Application Ref: NP/11/472

Application Type	Listed Building
Grid Ref:	SN05173904
Applicant	Dr R Jenkins
Agent	Mr Iain MacRae, MacRae Associates
Proposal	Extension to kitchen
Site Location	Highway, Newport, Pembrokeshire, SA42 0TY
Case Officer	Ceri Porter

Summary

2
North Elevation
1 : 100

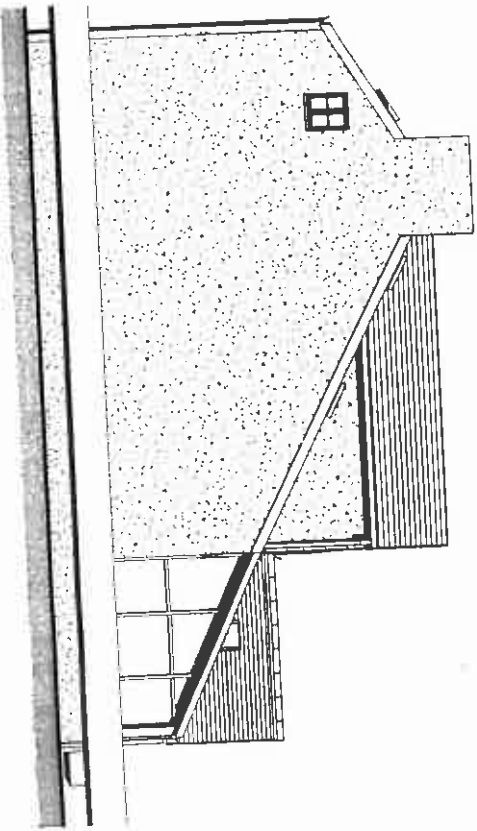
Of concern however is the design of the proposed dormer windows. Whilst the principle of dormer windows is considered acceptable, their design appears squeezed in proportions and the slate hanging appears over fussy in comparison with the proposed simple extension below. It is appreciated that the dormers have sought to reflect the existing dormer to the east however the design has failed to respect the character of the listed building.

The proposed dormer windows within the north elevation, by reason of their narrow width and design, would appear out of proportion and overdetailed and consequently appear as an incongruous addition to this grade II listed building. As such the proposal is contrary to policies 8 (d), 15(a)(b) and 30(d) of the Adopted Pembrokeshire Coast National Park Local Development Plan (September 2010).
